**COMMENTS OF THE NATIONAL ASSOCIATION OF CLEAN AIR AGENCIES
CONCERNING EPA'S PROPOSED NATIONAL EMISSION STANDARDS FOR
HAZARDOUS AIR POLLUTANTS AND PROPOSED REVISIONS TO THE NEW
SOURCE PERFORMANCE STANDARDS FOR FOSSIL FUEL- FIRED ELECTRIC
GENERATING UNITS**

Docket Nos. EPA-HQ-OAR-2009-0234; EPA-HQ-OAR-2011-0044

August 4, 2011

Chart 1. Coal-fired EGU Emissions by Unit

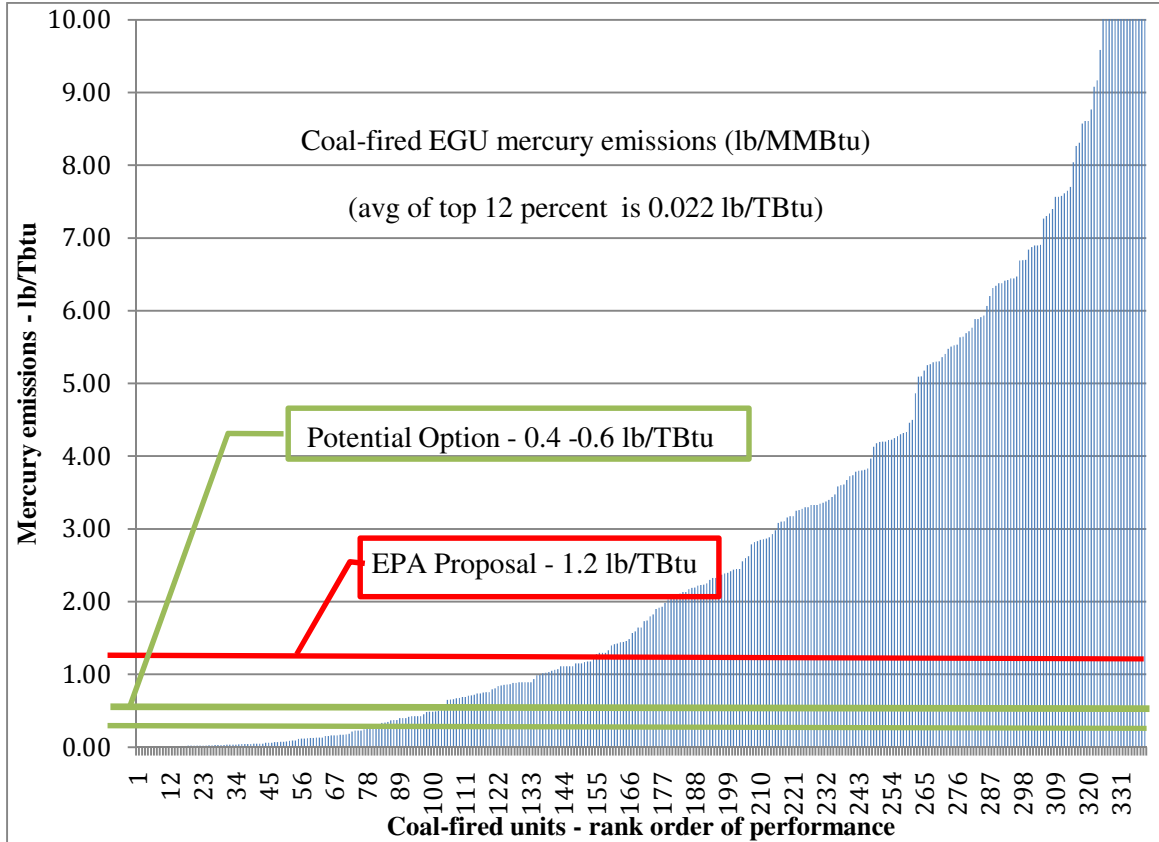
The chart below illustrates the substantial reduction in mercury emissions that will result from implementation of the proposed standard. It also demonstrates that the proposed limits are technically feasible. Nearly half (154/339) of the existing coal-fired units for which EPA has data has already been shown to be able to meet the proposed mercury limits.

NACAA believes that the proposed emission limitations are within the range of limits that should be considered reasonable. Chart No. 1, above, shows that EPA's proposed limits will, indeed, lead to significant mercury emission reductions and are supportable from a policy perspective. However, the CAA requires a very high degree of protection from HAPs emissions and does not provide EPA the broad discretion in setting MACT floors that it enjoys with respect to promulgating MACT standards ("beyond the floor") and to regulation of criteria pollutants. Many of the assumptions underlying the calculation of certain MACT floors are unsupported and/or inappropriate. NACAA suggests that use of the 99th percentile UPL is not in the public interest, and that the proposal's treatment of outliers and significant digits in the calculation
